VIRGINIA ELECTRIC AND POWER COMPANY
RICHMOND, VIRGINIA 23261

VIRGINIA ELECTRIC AND POWER COMPANY (DOMINION)
NORTH ANNA POWER STATION UNIT NOS. 1 AND 2
RESPONSE TO REQUEST FOR ADDITIONAL INFORMATION ON PROPOSED
TECHNICAL SPECIFICATION CHANGES ON ADDITION OF ANALYTICAL
METHODOLOGY TO THE CORE OPERATING LIMITS REPORT (TAC NOS. MC7526
AND MC7527)

**Response to Request for Additional Information on Proposed Technical
Specification Changes on Addition of Analytical Methodology to the Core
Operating Limits Report
(Tac Nos. MC7526 and MC7527)**

**Virginia Electric and Power Company
(Dominion)
North Anna Power Station Units 1 and 2**

FIGURE 1-1

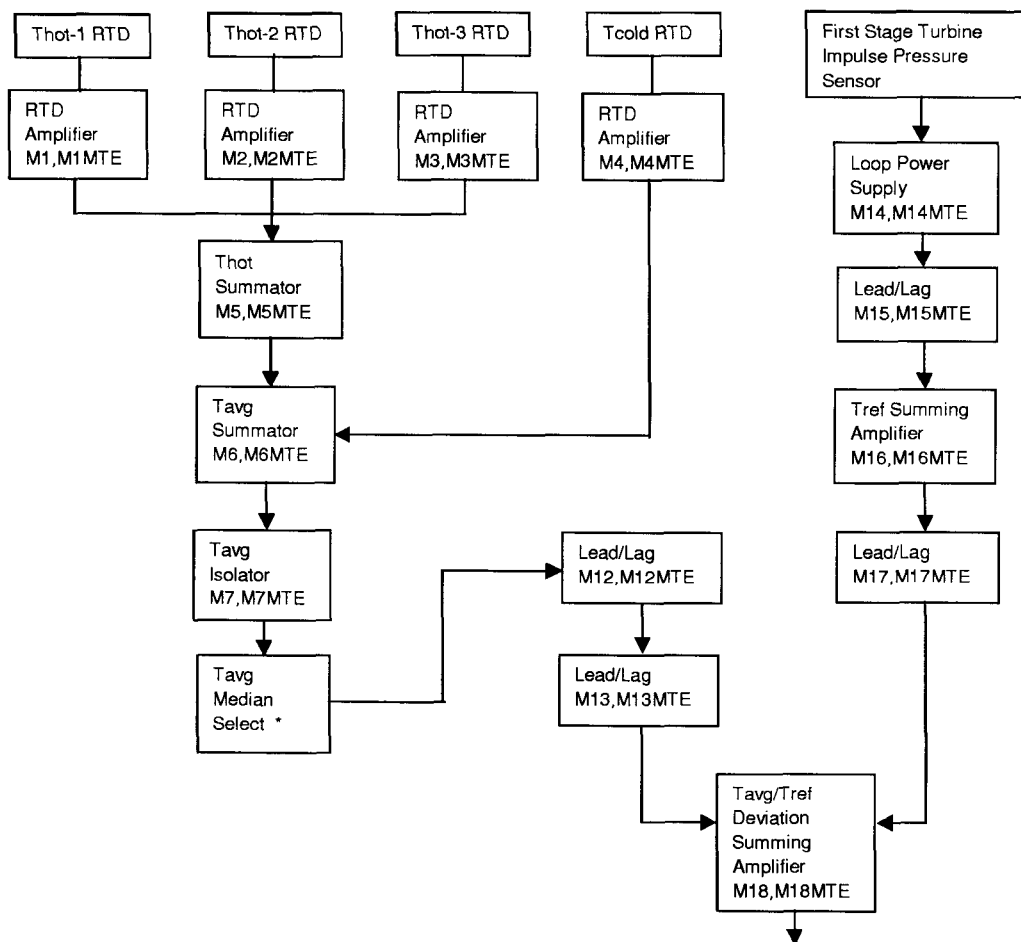
1. *Table 3.1.2-1 lists the uncertainties, probability distributions, nominal values and standard deviation of statistically treated parameters. These uncertainties and distributions deviate somewhat from that listed in Table 4.2-1 in Attachment 6 to Dominion Letter Serial No. 02-167 (L. N. Hartz to NRC, dated March 28, 2002).*

Provide the analyses performed to derive the uncertainty values and distributions of each of these parameters. The uncertainty analysis description should include, as appropriate, a block diagram depicting sensor, processing equipment, computer, and readout devices for each parameter channel. Within each element of the block diagram identify the accuracy, drift, range, span, operating limits, and setpoints. Identify the overall accuracy of each channel transmitter to final output and specify the minimum acceptable accuracy for use with the determination of the statistical design limit (SDL).

Dominion has quantified the magnitude and distribution of uncertainty on the pressurizer pressure (system pressure) per the pressurizer pressure control system. Figure 1-1 provides a simplified schematic of the pressurizer pressure control system. The current component accuracies for the pressurizer pressure control loop are shown in Table 1-1. In Reference 1, the pressurizer pressure uncertainty was quantified as a normal, two-sided, 95% probability distribution with a magnitude of $\pm 3.30\%$ of an 800 psi span or ± 26.4 psi. Subsequent to our submittal, the calculation was revised to reflect the inclusion of a revised STE (increase from 0.713% to 1.425%) for the pressure transmitter to reflect a wider variation in containment ambient temperature. The pressurizer pressure uncertainty is presently quantified as a normal, two-sided, 95% probability distribution with a magnitude of $\pm 3.55\%$ of an 800 psi span or ± 28.4 psi.

The pressurizer pressure uncertainty was conservatively applied in Reference 1 as a normal, two-sided, 95% probability distribution with a magnitude of ± 30 psia and a standard deviation (σ) of 15.306 psia. This assumed uncertainty represents the minimum required accuracy for the pressurizer pressure and bounds the quantified uncertainty.
